# E-3 AWACS CORROSION PREVENTION ADVISORY BOARD (CPAB)

12 JULY 1990  
TINKER AFB, OK

**E-3 CORROSION PREVENTION ADVISORY BOARD MINUTES  
12 JULY 1990**

SEE NOTE ON PARTS LIST PAGES  
 FIGURE 67 SPFAKER INSTL. NOSE GEAR

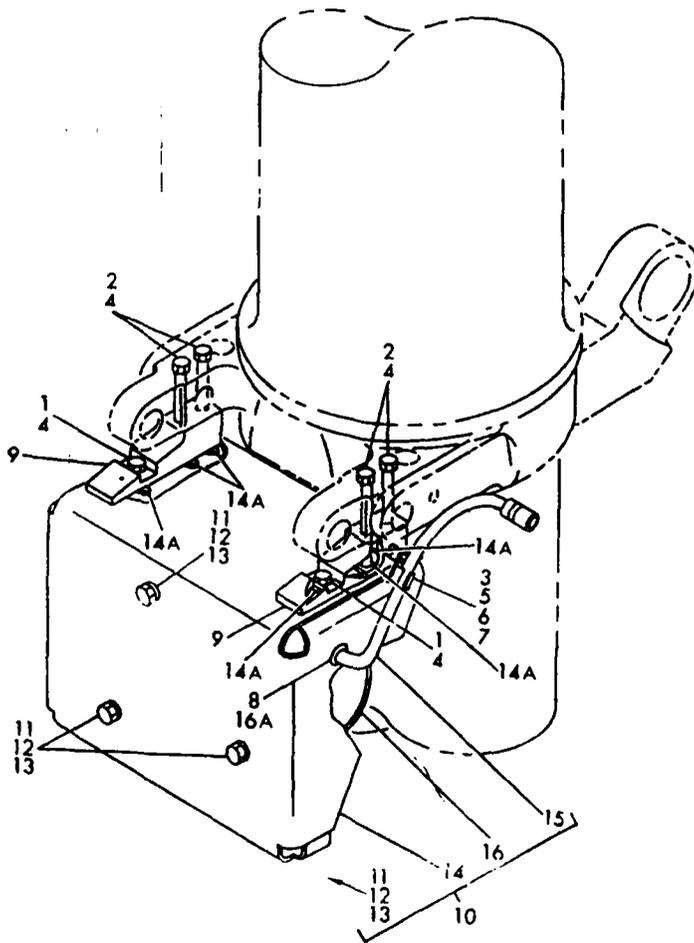
OC-ALC/MMKRTA has already requested stocklisting for the parts. No further action to be taken on this Action Item.

SEE NOTE ON PARTS LIST PAGES  
 FIGURE 13 ANTENNA INSTL, VHF/UHF STATION 600L, 844 AND 930 BLAD

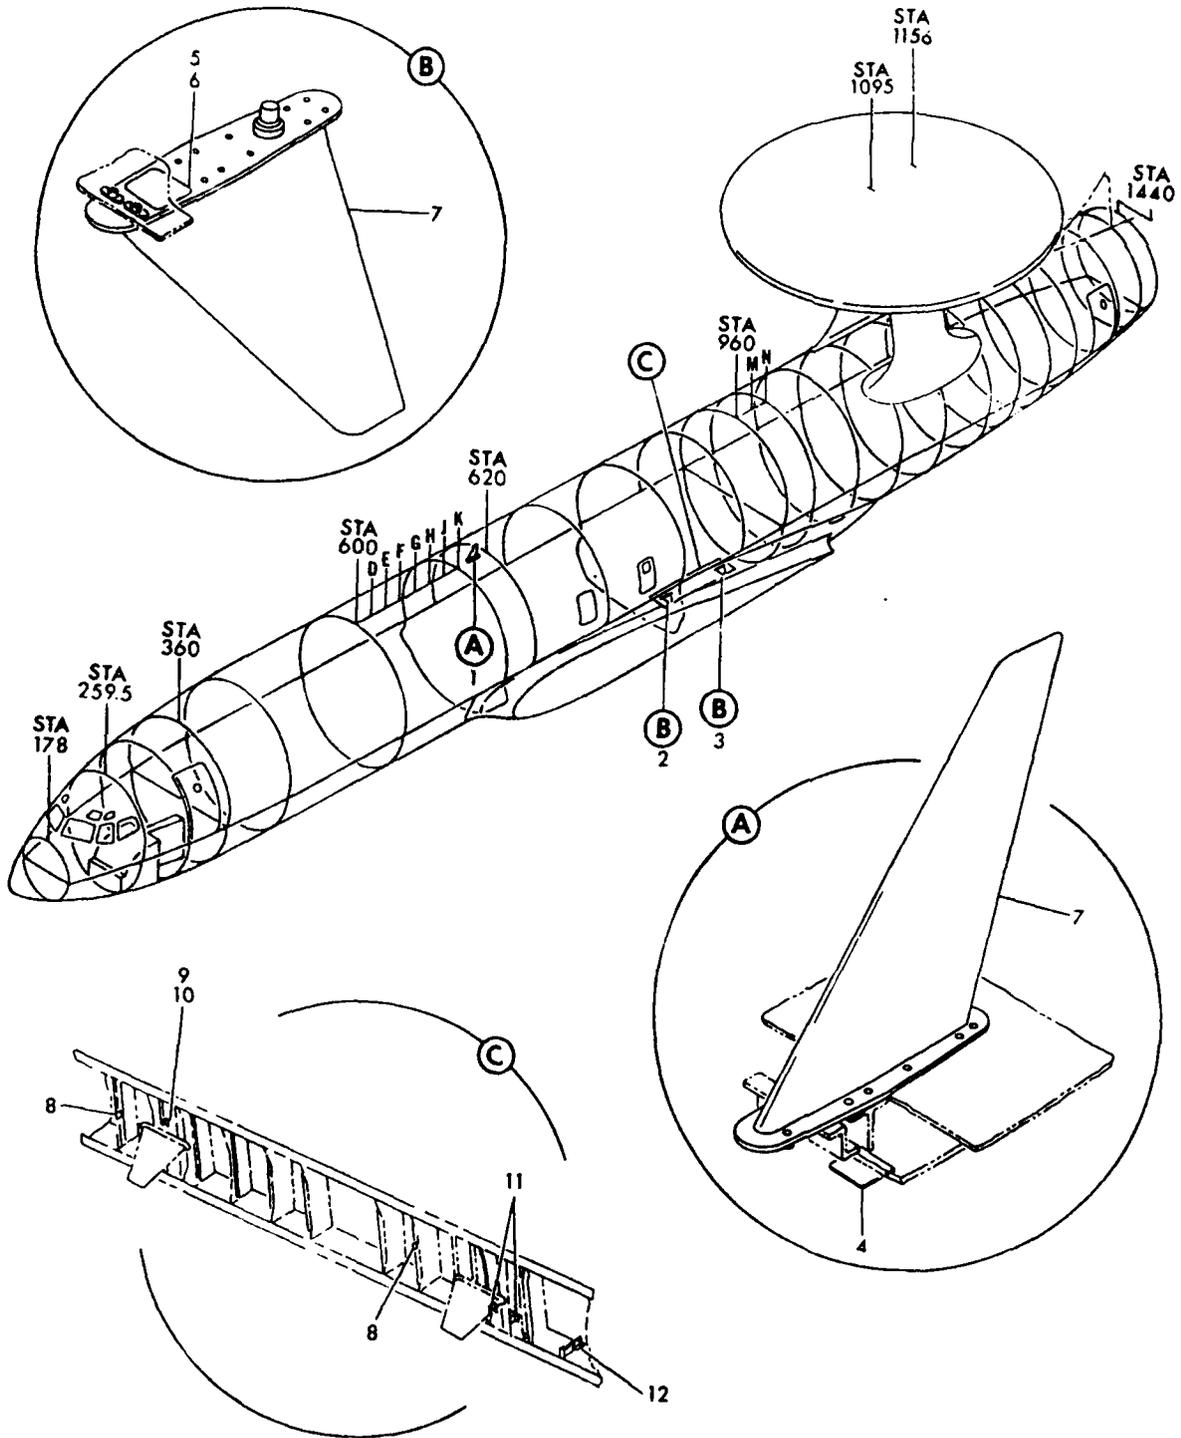
OC-ALC/MMKRTB has tentatively approved painting the aluminum leading edges of the antennas and applying LE erosion tape. Once formally approved by MMKRTB in writing, a TCTO will be generated to accomplish painting/tape application, and the Tech Orders will be changed to show the new requirement.

MMKRA is working on statement of work for MMKRTA to generate TCTO. 552 AWACW requested form 252 be issued if SOW is not necessary. MMKRA took action to change T.O. rather than issue TCTO.

Figure 4-9. First Body Section Nose Gear Wheel Well Corrosion Inspection Guide (Sheet 1 of 2)

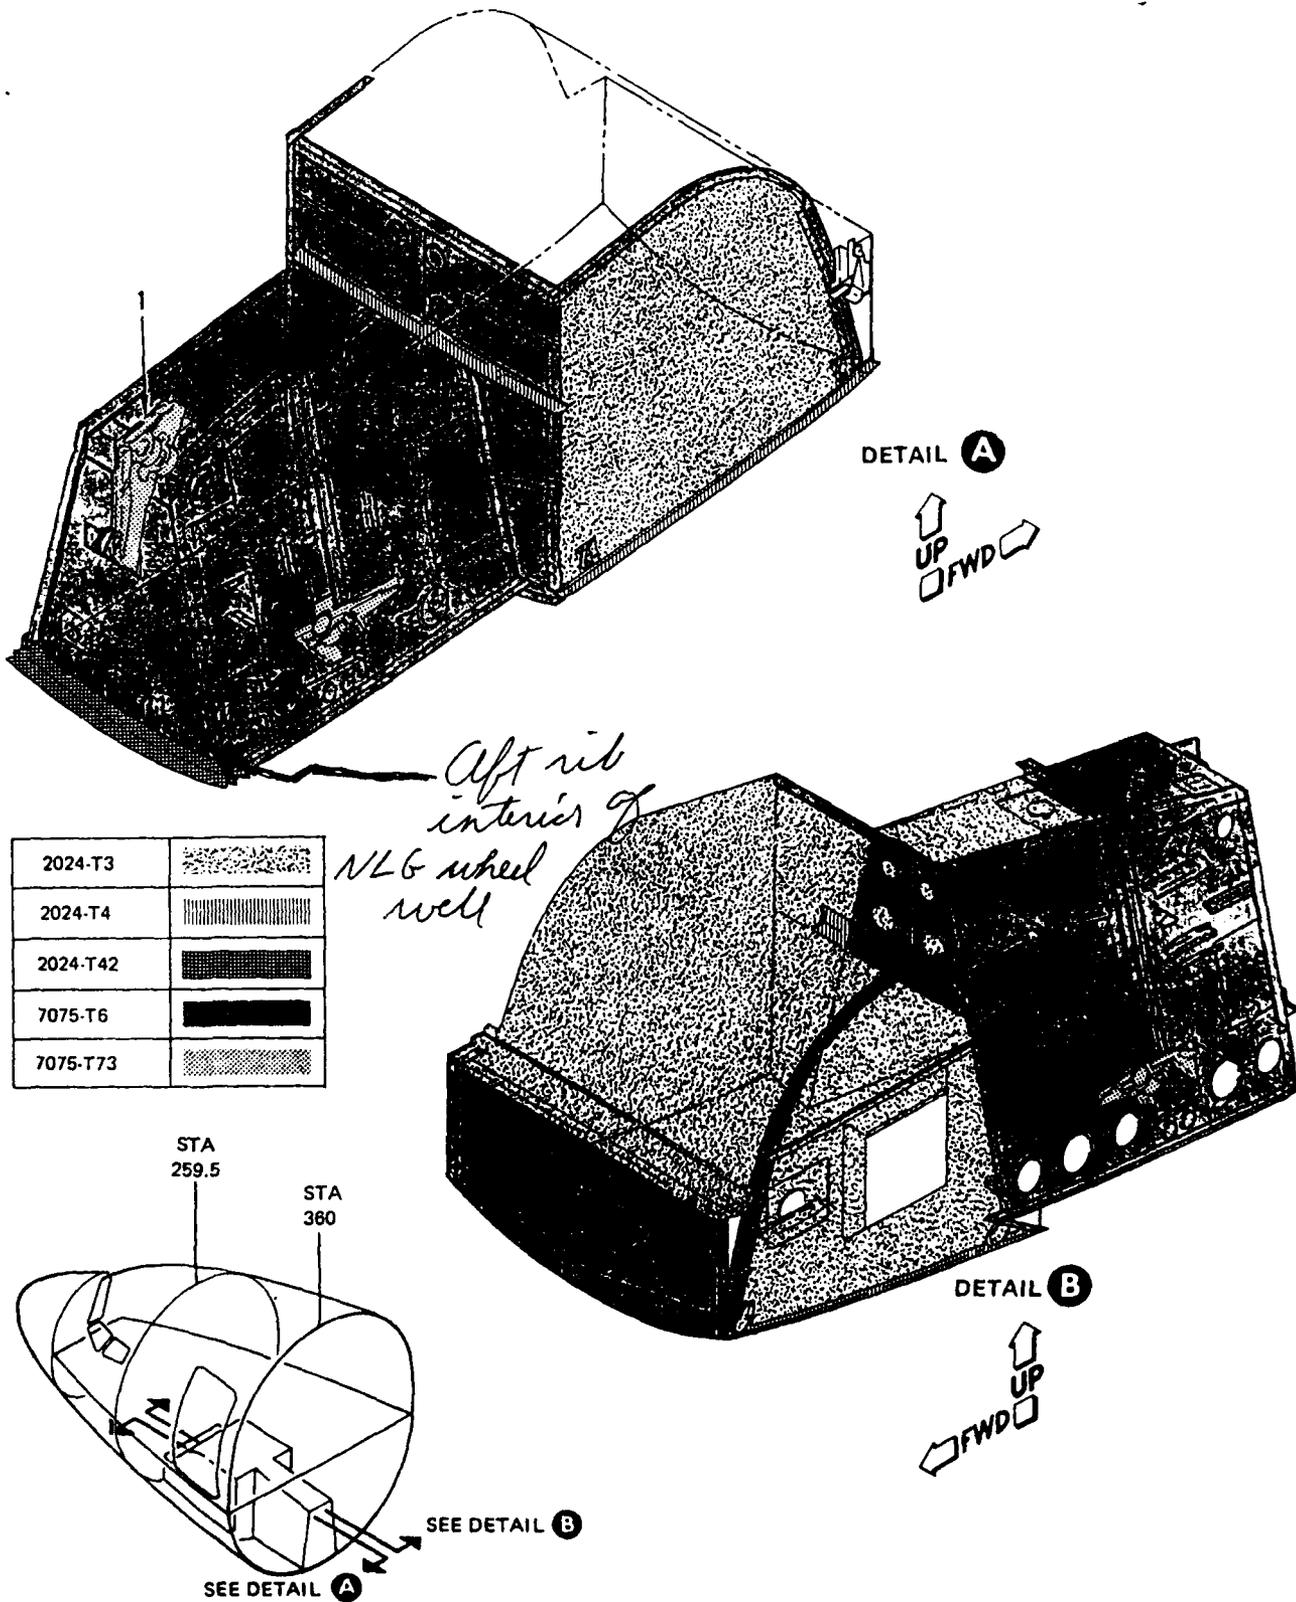
NAEWF E-3A Comp. reported that A/C 0442 through 0453 has no drain hole but sealant. A/C 0454 through 0459 has drain hole but no sealant. MMKRA/552 AWACW will take action to inspect USAF aircraft.

Figure 2-27. Wing Inboard Flap Structure Identification and Repair Index (Sheet 1 of 3)

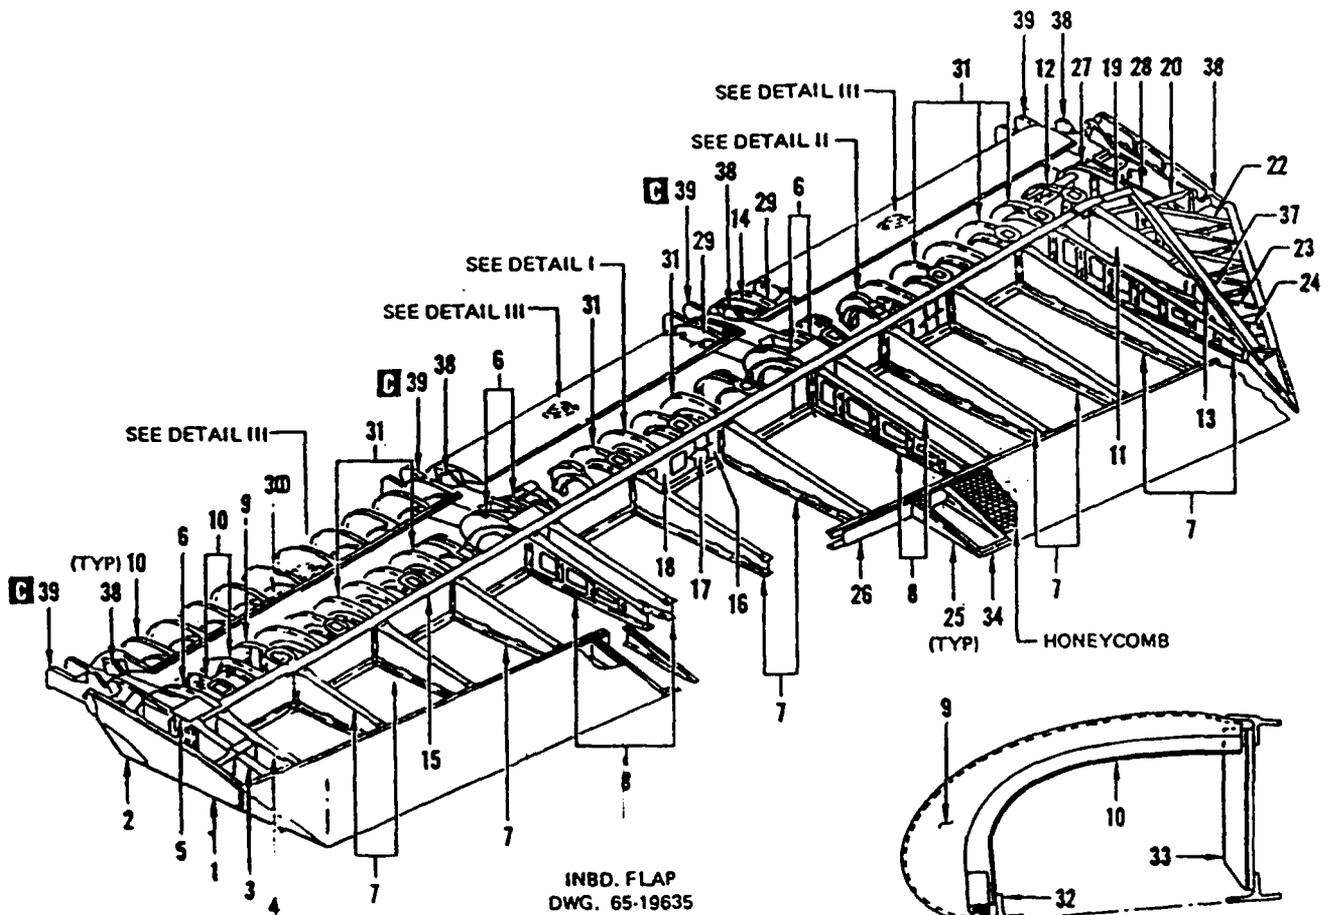
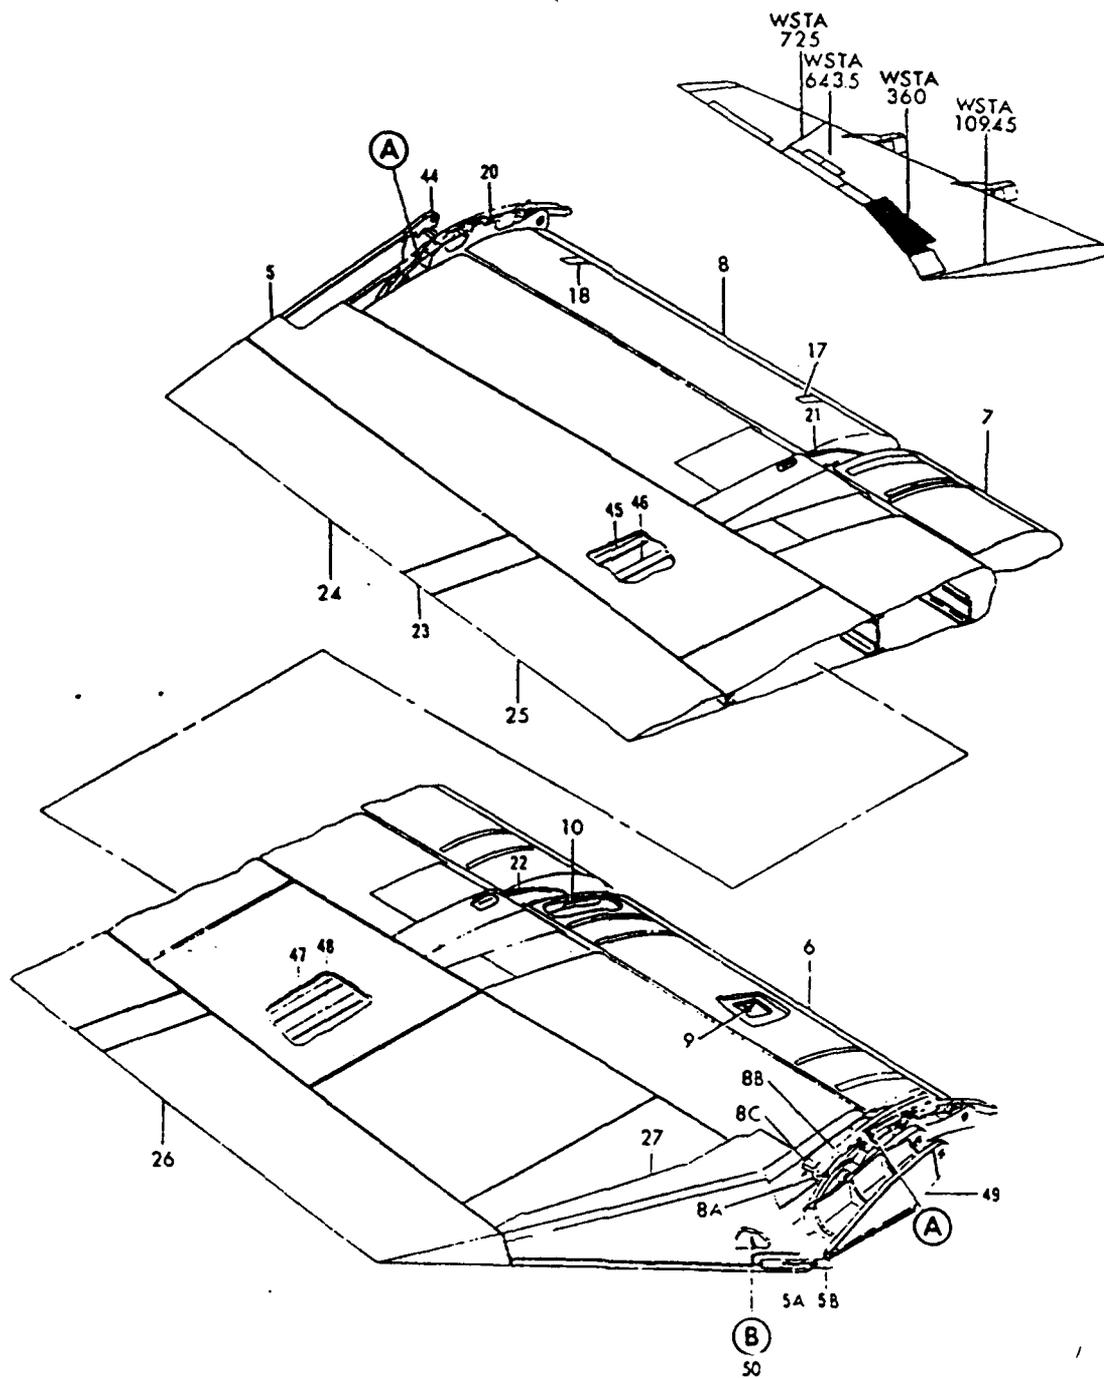
E-3	CORROSION PREVENTION ADVISORY BOARD	ACTION ITEM #: 89-11
O R I G I N A L T O R	<b>SUBJECT:</b> Inboard Trailing Edge Flap	<b>BACKGROUND DATA:</b> <b>PART NUMBER:</b> 65-18441-61/-62 <b>NSN:</b> <b>DRAWING(S):</b>
	<b>NAME:</b> HFw Franz-Josef Deckers <b>ORGANIZATION:</b> NAEWF E-3 Comp. <b>TELEPHONE:</b> 01-49-2451-63-6215 <b>DATE SUBMITTED:</b> 16 NOV 1989	<b>TO(S):</b> 1E-3A-4-27-1 <b>FIGURE:</b> 27-06-12 <b>INDEX:</b> 23 <b>WORK UNIT CODE:</b>
	<b>PROBLEM:</b> Water is collecting in the inboard flap cavity. After removal of cover assy, 65-18441-33, excessive corrosion was found on the rivet nuts on bolt heads, as well as light corrosion on the flap structure. A/C 79-0454 and 79-0449 were inspected and the same condition was discovered.	
<b>RECOMMENDED ACTION:</b> Install drain holes in the inboard edge of the lower cover assembly  <p style="text-align: center;">(USE CONTINUATION SHEET IF NECESSARY)</p>

C P A B  A C T I O N	<b>STATUS:</b> 16 Nov 1989: OC-ALC/MMKRA will investigate, prepare ECO, and coordinate TCTO with OC-ALC/MMKRTA to install drain hole(s) as necessary to correct problem.  12 March 1990: No action has been taken yet by OC-ALC/MMKRA.  July 1990: OC-ALC/MMKRTA is generating a TCTO to inspect and install drain hole(s) as necessary. Kitproof/publication scheduled for late Sept 90.	
	<b>ACTION OPR(S):</b> OC-ALC/MMKRA	<b>POINT(S) OF CONTACT:</b> Lt. Jim Kihle
<b>STATUS:</b> OPEN <b>DATE CLOSED:</b> <b>FINAL DISPOSITION:</b>

SEE NOTE ON PARTS LIST PAGES  
 FIGURE 17. FAIRING INSTL. STA 990 TO 1060 WING TO BODY (SHEET 3)

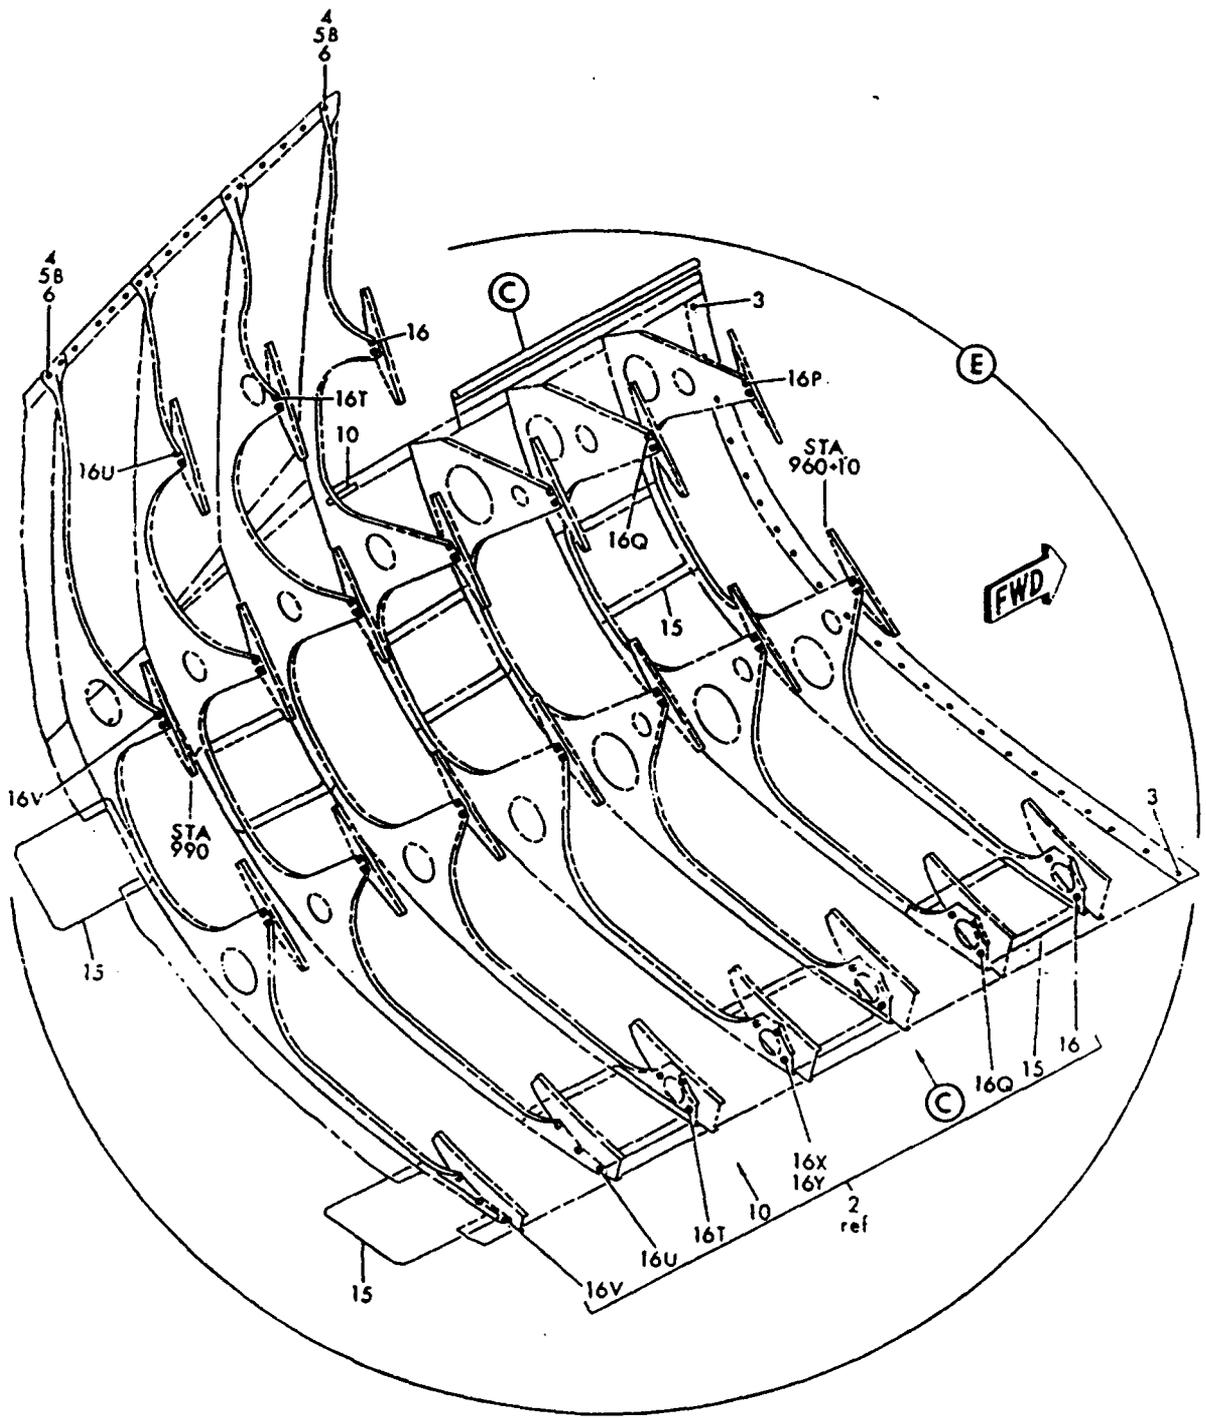
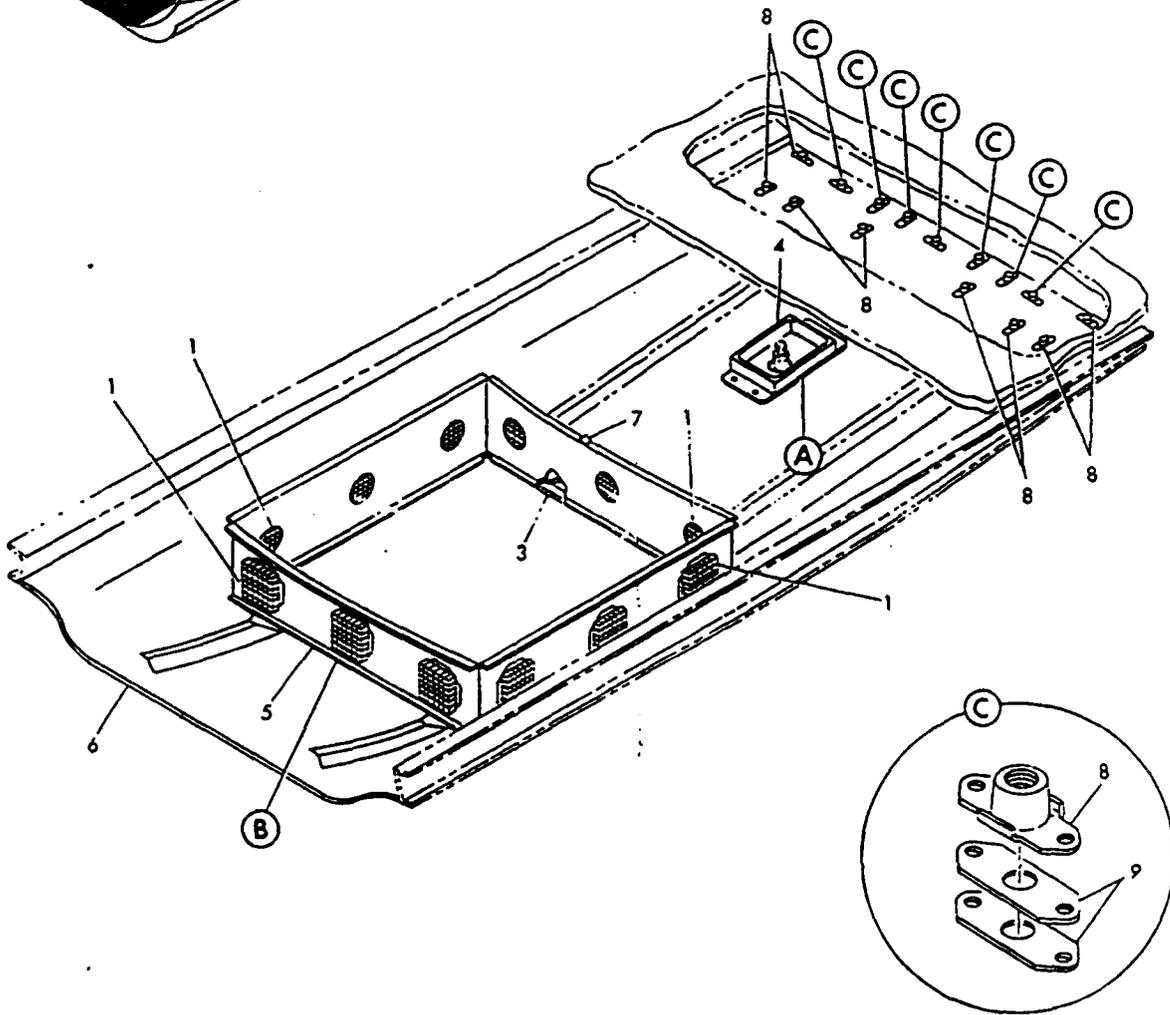
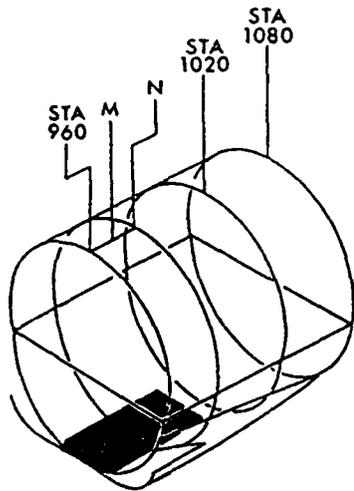
E-3	CORROSION PREVENTION ADVISORY BOARD	ACTION ITEM #: 89-12
O R I G I N A L T O R	<b>SUBJECT:</b> Fairing Installation STA 960 to 1020, Wing to Body	<b>BACKGROUND DATA:</b>  <b>PART NUMBER:</b> 65-22871-31  <b>NSN:</b> <b>DRAWING(S):</b>
	<b>NAME:</b> HFw Franz-Josef Deckers <b>ORGANIZATION:</b> NAEWF E-3 Comp. <b>TELEPHONE:</b> 01-49-2451-63-6215 <b>DATE SUBMITTED:</b> 16 NOV 1989	<b>TO(S):</b> 1E-3A-4-53-1 <b>FIGURE:</b> 53-02-7A <b>INDEX:</b> 48 <b>WORK UNIT CODE:</b>
	<b>PROBLEM:</b> Water is collecting in the wing to body fairing. Existing drain holes in the lower frame are too high, resulting in water level being 1/2" high before draining.	
<b>RECOMMENDED ACTION:</b> Install drain holes in the lowest spot of both wing to body fairings.  (USE CONTINUATION SHEET IF NECESSARY)		
C P A B  A C T I O N	<b>STATUS:</b> 16 Nov 1989: OC-ALC/MMKRA will investigate problem, prepare ECO, and coordinate TCTO with OC-ALC/MMKRTA to install drain hole(s) to correct problem.  OC-ALC/MMKRA will also investigate related water collection problem with the doppler velocity sensor cavity aft of the MLG wheel wells.  12 March 1990: ECO's documenting additional drain holes have been submitted by MMKRA. OC-ALC/MMKRTA is preparing a TCTO to install the drain holes. Once installed, drainage should be sufficient to correct water retention problems in the fairings and the doppler velocity sensor cavity.  July 1990: TCTO is being written by MMKRTA and will be finished by next CPAB. 552 AWACW/MAQ is setting up kitproofing.
